Subject RE: Ootzie of Ohio

Subject Ootzie of Ohio, truck parking lot issues

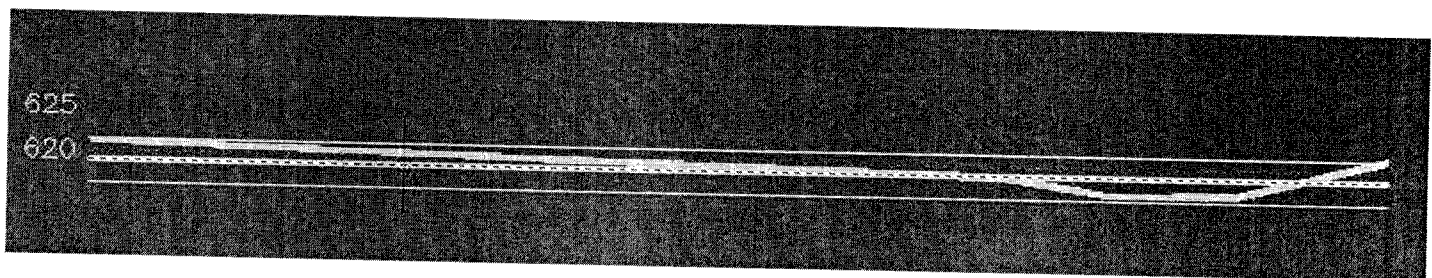
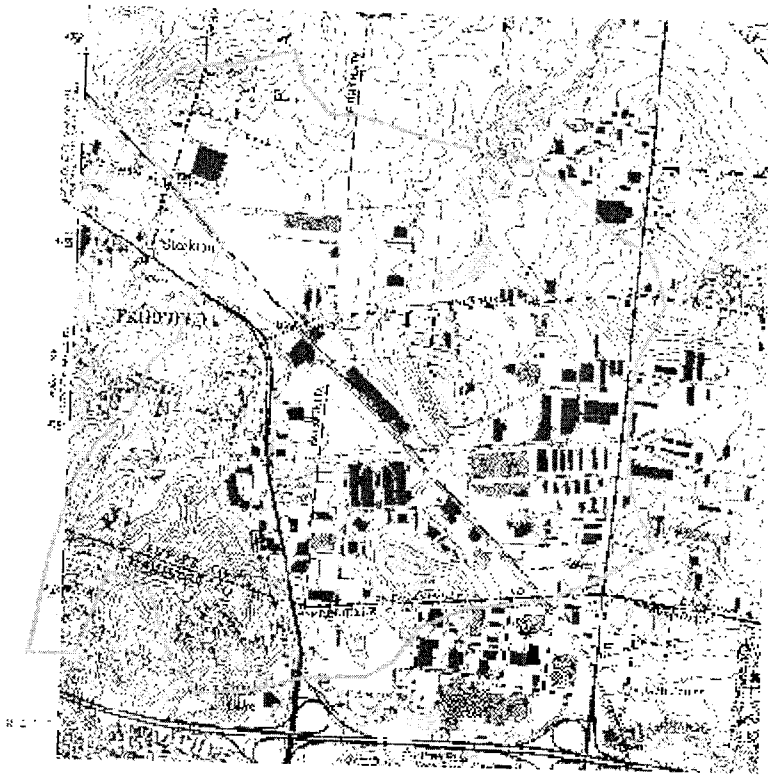
The site location is on the bank of a tributary stream approximately 5600 feet from its terminus at Mill Creek. The drainage area contributing to the stream at our Water quality pond is estimated to be 3.01 square miles. The area is highly developed. I have shown below the estimated drainage area from the USGS map.

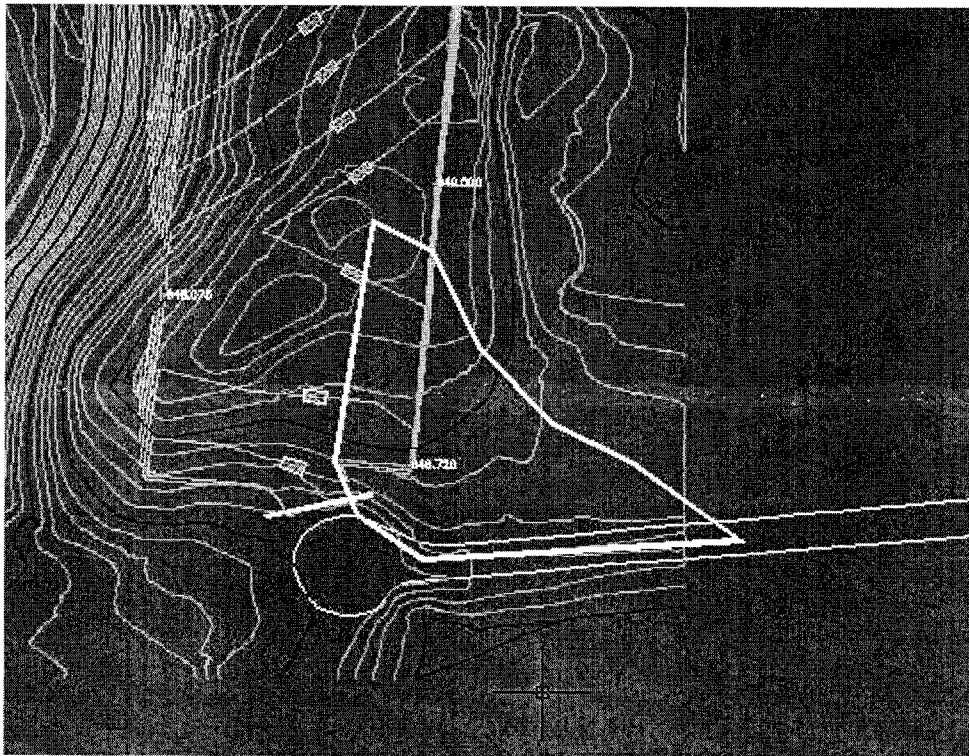
The access permit states that we (the engineer's office) will size a pipe for non-commercial applications. Therefore, we require the culvert sizing calculations as well.

The drainage area for the culvert is very small and is shown below.

$A=.65$  Ac by CAD takeoff

$C=.8$  by OEPA NOI estimate for industrial / commercial zones

$I_{10yr} = 5.4$  in / hr (assume 10 min travel time)

$Q = .8 * 5.4 * .65 = 2.808$  CFS

By ODOT 1100-245, a 15" CMP culvert flowing full handles 4 CFS. This size culvert will be specified for safety factor.
